SUBJECT: Revised Requirement Addressing End-Structure Entrapment
 In Bunk Beds

BRIEFING PACKAGE FOR BUNK BED REPROPOSED RULE

SUBJECT: Revised Requirement to Address Entrapment in Bunk Bed End Structures

Bunk Beds; Request for Additional Comment

Fig. A - End Structure of Bed Involved in Fatal Entrapment Incident Described in IDI #961126CWE5015

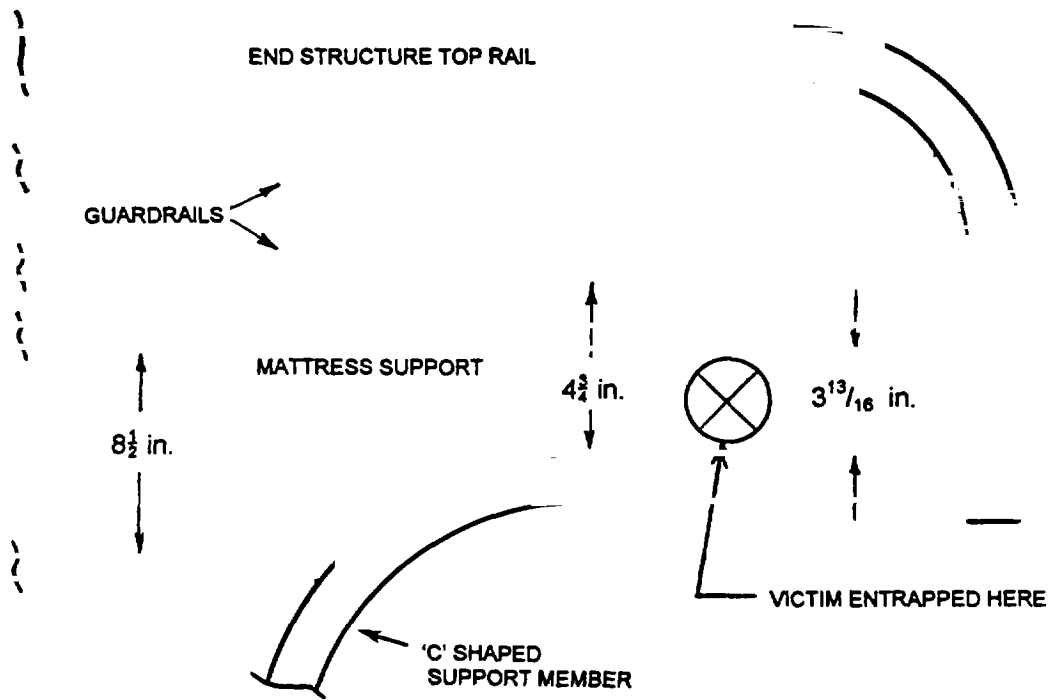
At an April 21, 1999 meeting of the ASTM subcommittee, there was discussion on a change to the requirement in the ASTM standard addressing entrapment in lower bunk end structures in order to make it the same as that in the Commission's proposed rule. As the details of the entrapment death of a 22-month-old child in a lower bunk end structure (CPSC IDI #961126CWE5015) were discussed, it appeared that even if the opening in the metal bunk bed that was involved in the fatality (see attached Figure A) were modified to conform to the proposed requirements, the bed would still present an entrapment hazard. In this incident, it is likely that the child placed his head through the wide portion of the opening then moved sideways until his neck was in the narrow portion of the opening. (Note: The 22-month-old child’s head is too large to have been placed through the narrow portion of the opening.) While his neck was in the narrow portion of the opening, his feet apparently slipped off the mattress of the lower bunk, suspending him by his head, and he strangled.

In order for this bed to conform to the proposed requirement, the vertical dimension of the wider portion of the subject opening should be greater than 9 inches and the vertical dimension of the narrower portion should be less than 3½ inches. (see attached Figure B). However, since a 22-month-old child’s neck is significantly less than 3½ inches in diameter, the child could still become entrapped in the manner described in the Commission’s investigation report.

**Fig. C – End Structure of Bed Modified to Add Vertical Bar
Preventing Neck Entry into Narrow Portion of Opening**

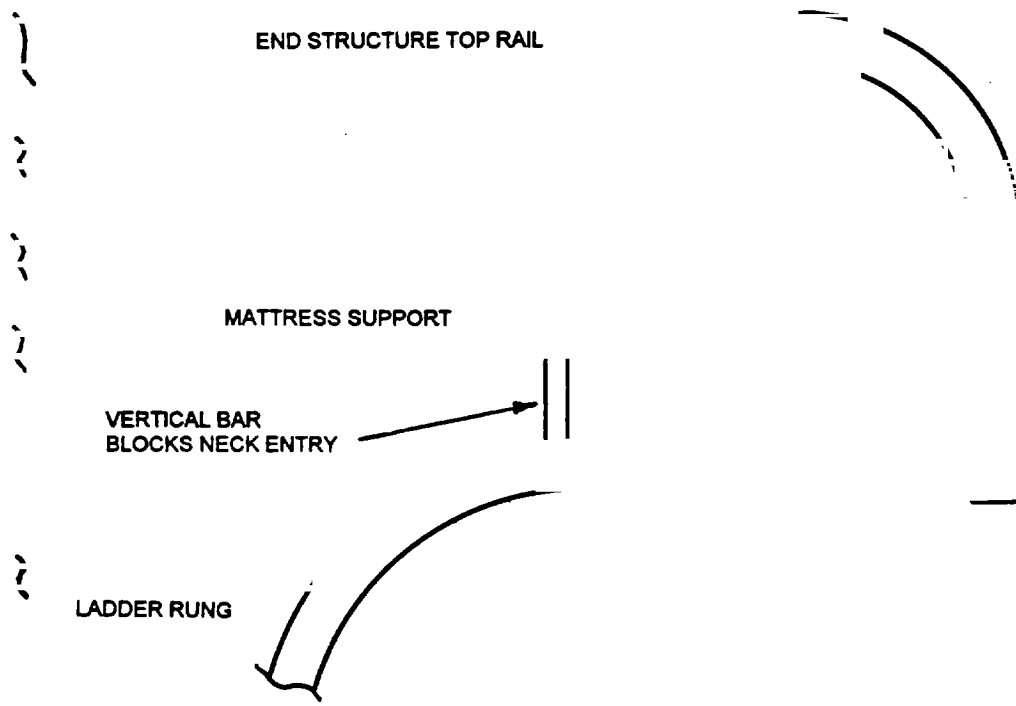
There are two ways to modify the bed to prevent this type of entrapment. First, a vertical bar could be added to separate the wide and narrow portions of the opening (see attached Figure C). A second approach would be to reduce the vertical dimension of the narrow portion of the opening to less than 1⅞ inches, which is considered sufficient to prevent entry of the neck of a 5th percentile 2-year-old, accounting for tissue compression. (see Figure D).

**Revised Test Method & Requirements for Lower Bunk End Structures
New CPSA §1213.4(c)(3) and New FHSA §1513.4(c)(3)**

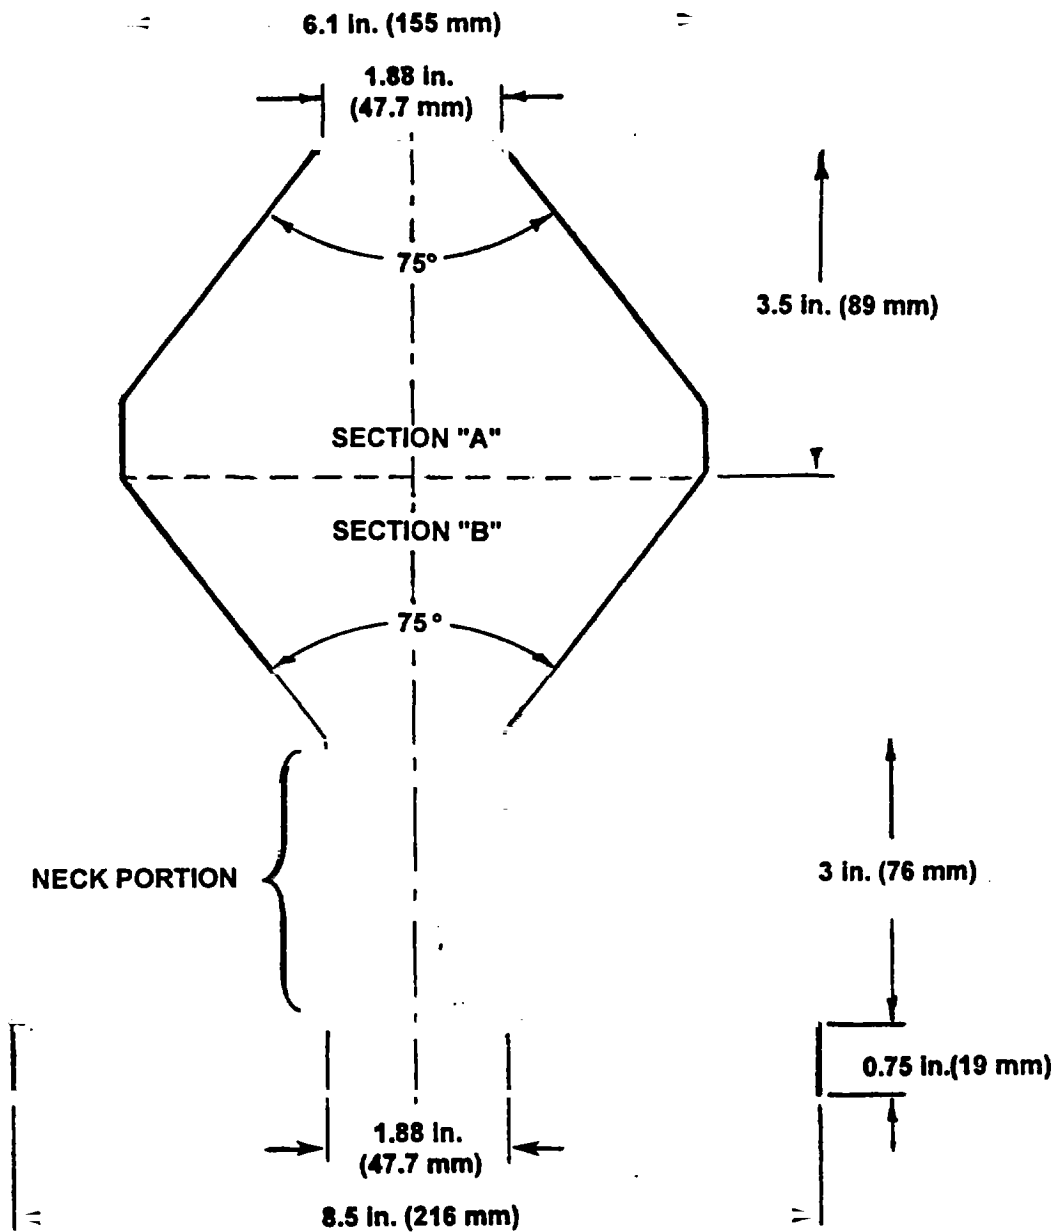
The following requirement is proposed to address neck entrapment as a new section at CPSA §1213.3(b)(4). The same provision would apply under the FHSA as a new section numbered 1513.3(b)(4).

(4) All portions of the boundary of any opening required by §§ 1213.4(c)(1) and (2) to be probed by the wedge block of Fig. 1 of this part, and that permits free passage of a 9-inch diameter sphere, must conform to the neck entrapment requirements of § 1213.4(c)(3).

(i) Insert the "A" section of the test template shown in Fig. 2 into the portion of the boundary of the opening to be tested, with the plane of the template in the plane of the opening and with the centerline of the top of the template aligned parallel to the centerline of the opening, until motion is stopped by contact between the test template and the boundaries of the opening (see Fig. 3 of this part). By visual inspection, determine if there is simultaneous contact between the boundary of the opening and both sides of the "A" section of the template. If simultaneous contact occurs, mark the contact points on the boundary of the opening and conduct the additional test described in paragraph (c) (4) (ii) of this section.

(ii) To check for the potential for neck entrapment, place the neck portion of the "B" section of the template into the opening, with its plane perpendicular to both the plane of the opening and the centerline of the opening (see Fig. 4 of this part). If the neck portion of the "B" section of the template completely enters the opening (passes 0.75 inch or more beyond the points previously contacted by the "A" section of the template), the opening fails the test, unless its lower boundary slopes downward at 45 degrees or more for the whole distance from the narrowest part of the opening the neck can reach to the part of the opening that will freely pass a 9-inch diameter sphere.

Fig. 3 - Motion of Test Template Arrested by Simultaneous Contact with Both Sides of "A" Section and Boundaries of Opening

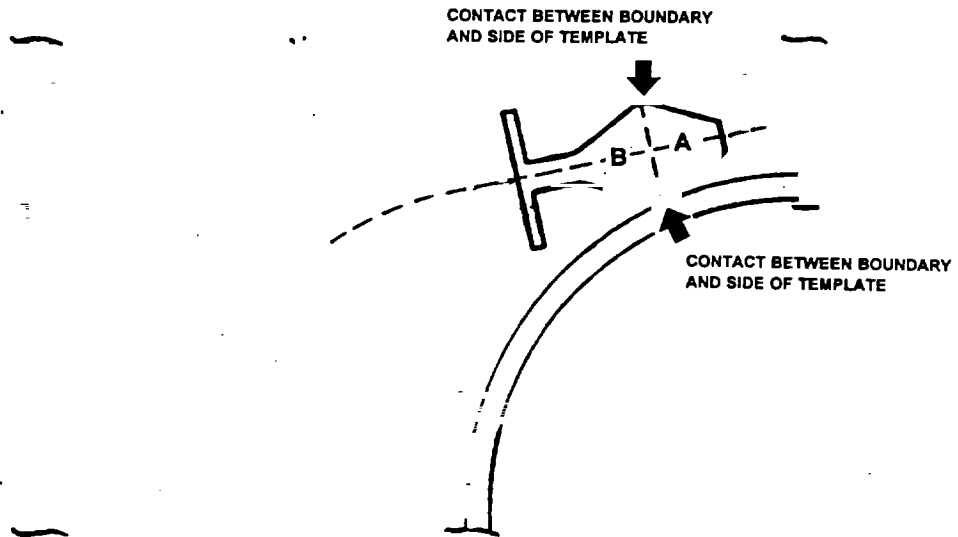
The template is used to protect against head-first entrapment as follows. First, all portions of the boundary of the opening are probed with the "A" section of the test template of Fig. 2. The template is inserted into the opening, with the plane of the template in the plane of the opening and with the "top" of the template perpendicular to the centerline of the portion of the boundary being probed. The template is then moved along the centerline of the portion of the boundary being probed until it is stopped by contact with the boundaries of the opening (see Fig. 3).³

Fig. 4 – Neck Portion of “B” Section of Template Enters Completely into Opening

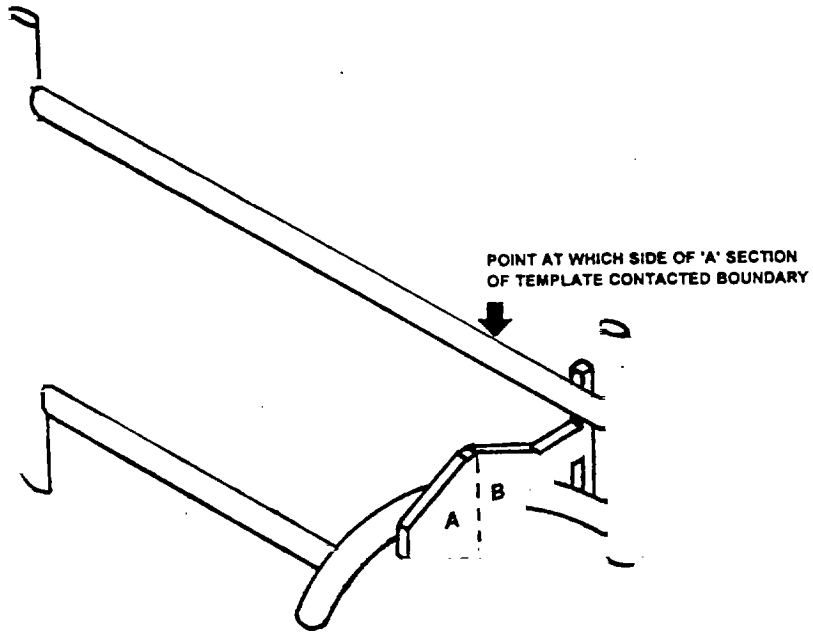
To check further for the potential for neck entrapment, place the neck portion of the "B" section of the template into the opening, with the template's plane perpendicular to both the plane of the opening and the centerline of the opening (see Fig. 4). If the neck portion can completely enter the opening (pass 0.75 inch or more beyond the points where contact with the sides of the "A" section of the template occurred), the opening may present a neck entrapment hazard. Such an opening is not allowed unless the lower boundary of the opening slopes downward at 45 degrees or more for the whole distance from the narrowest part of the opening the neck can reach to the larger (greater than 9-inch) part of the opening.
